**Final LUPC Staff Report for the Small Lot Subdivision Application To Build 2 New SFDs  
LUPC Hearing: April 16, 2014; VNC Board Hearing: April 29, 2016**

**Project Address:** 750 California Avenue

**Case Numbers:** ZA 2013-2003-CDP-MEL-ZAA;

PROJECT  
CALIFORNIA RESIDENCE  
750 CALIFORNIA AVENUE  
VENICE BEACH, CA 90291

**A-5**

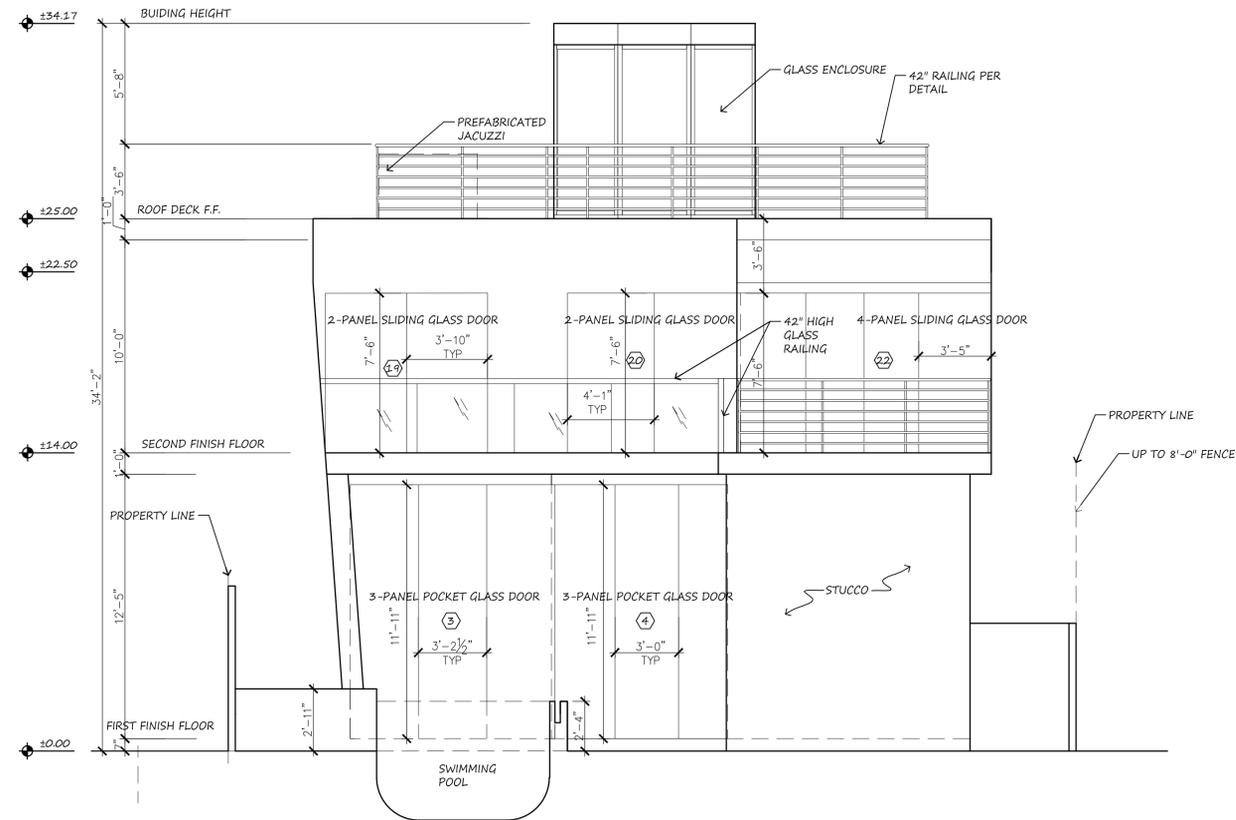
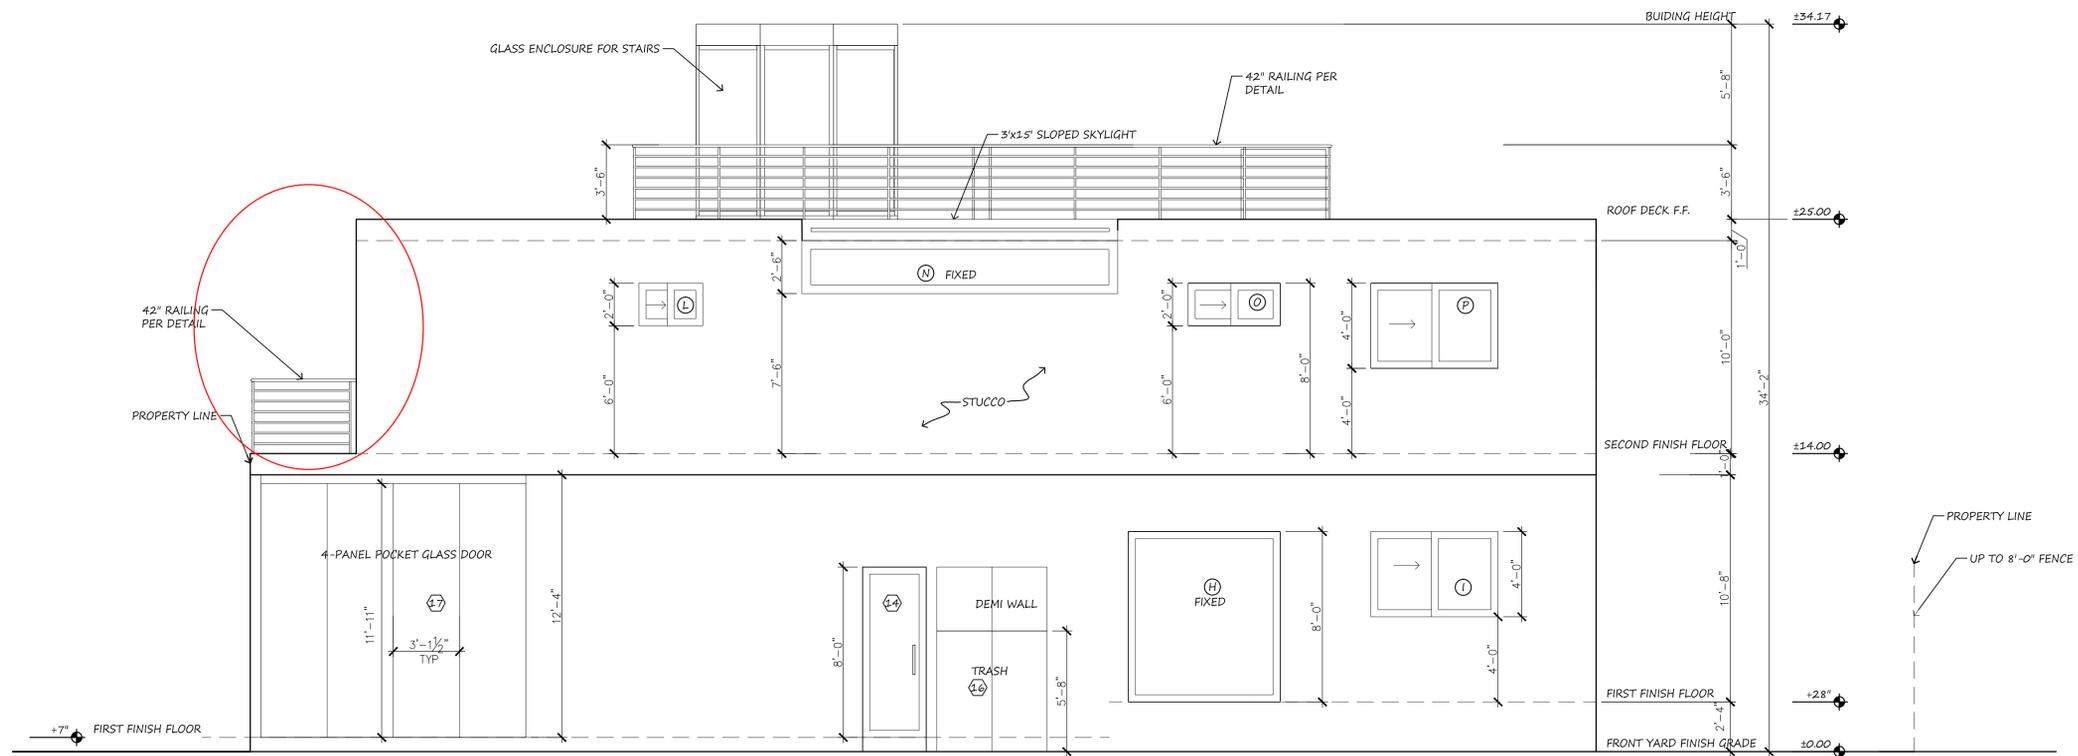
4. The VNC supports the applicants' request for a 4-inch building separation in lieu of the required 10-foot separation between the front and rear buildings,, but only on the first floor of the proposed buildings, and only on the condition that there is a 5' building separation at the second floor between the proposed buildings, and this opening is shown on the building plans approved by the City, as indicated in the area circled in red on page A-5 on the plans for the front house (750 California Ave.).
